Re: Response to DOE Comments and Additional Comments on NRC's Safety Evaluation Report of UNC License Amendment Request dated September 24, 2018
Church Rock Mill Site, Gallup, New Mexico
NRC Source Material License SUA-1475

Attachment I – Response to DOE Office of Legacy Management’s (LM) Comments on SER

Attachment II – UNC Comments on SER

Fig. 13: Suggested value of the retention criterion for granular filters, for a dense soil, interpolated between the hyperstable and mesostable cases. (The dashed line represents the classical retention criterion for granular filters, Equation 72.)

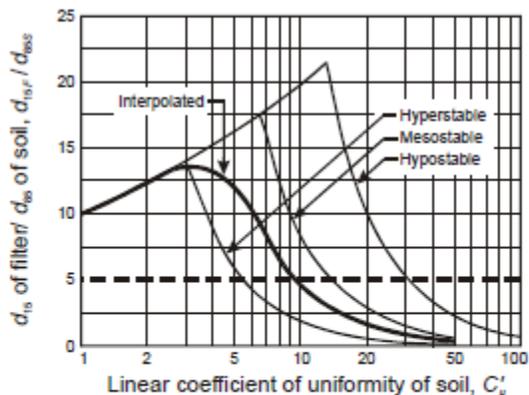
- c. Sheet 9-11, Mill Site Repository Area Stormwater Controls, Riprap Chute Details, Detail #2B, Typical Chute Riprap and Bedding Detail, and Appendix I, Attachment I.3, Filter Compatibility Calculations for Mill Site and Mine Site Stormwater Controls: There is a large gradation gap between the top filter layer and the 27-inch riprap. Our concerns are the interstitial velocities in the area of the hydraulic jump where the top filter layer could effectively become a wearing layer as particles are slowly removed. NUREG 1623 was used to design the filter at the bottom of the Pipeline Arroyo Chute. DOE does not believe that NUREG 1623 is the correct design guidance criteria for this application. DOE suggests you consider the following references as well: U.S. Department of the Interior, Bureau of Reclamation (BOR), 1987. Design of Small Dams <https://www.usbr.gov/pn/programs/ea/wash/potholes/techreport-alta-attachmentK.pdf> and Mishra, S.K., J.F. Ruff, 1998. Riprap Design for Overtopped Embankments. Final Report. Prepared for U.S. Bureau of Reclamation. https://www.usbr.gov/tsc/techreferences/hydraulics_lab/pubs/PAP/PAP-0809.pdf. Both could be useful.

UNC Response to 7c: The Stantec design document (Attachment I.3) presented an analysis of filtering capabilities between the top filter layer (Type II Filter) and the $D_{50} = 24$ -inch riprap material using the Terzaghi method which provides if the ratio of the D_{15} of the Riprap layer (D_{15r}) and the D_{85} of the Type II Filter layer (D_{85f}) is less than 5 then there will not be sufficient void space in the riprap layer for the sub-layer to wash through. This is consistent with recommendations in USBR (1987) (see Page 218 of the manual).

Table 3 of Attachment I.3 provides the computed ratio of the proposed materials is 4.92. This value is computed using average sizes within the material gradation limits presented in Table 1 and Table 2. From analyzing the extremes of the provided gradation limits, the maximum D_{15r}/D_{85f} that could occur within the specified gradation limits is 7.4. More recent research by J.P. Giroud (see reference below) notes the simplistic retention criteria (Terzaghi Criteria) does not account for the internal stability of the soil structure and that the actual threshold for soil stability as defined by D_{15r}/D_{85f} is not constant but rather varies with the coefficient of uniformity of the sub-layer. This is illustrated in Fig. 13 provided below taken from Giroud, 2003 which indicates the variable retention criteria suggested by Giroud using the thick solid line and constant retention criteria suggested by Terzaghi using the thick dashed line. The specified Type II material

coefficient of uniformities (defined by D_{60}/D_{10}) that could occur within the specified gradation limits of the Type II filter material is between 7.5 and 2.9. The interpolated curve (thick solid line) from Fig. 13 suggests D_{15f}/D_{85b} values of 7.5 or less will be stable within the range of potential Type II Filter material coefficients of uniformity. This finding by Giroud is supported by the testing completed by Mishra and Ruff (1998). This document presents results of tests on riprap materials of $D_{50}=15$ -in, 26-in, 11-in. riprap materials placed over a filter bedding layer. The bedding materials used had a D_{50} between 1.5-in. and 1.9-in and a coefficient of uniformity of approximately 1.6. The filter compatibility between the tested riprap and bedding materials (i.e., D_{15f}/D_{85b}) is 3.5, 7.0, and 2.7 respectively. Even in the case where the D_{15f}/D_{85b} is equal to 7 (greater than 5) no washout of the bedding layer was reported in the test result findings.
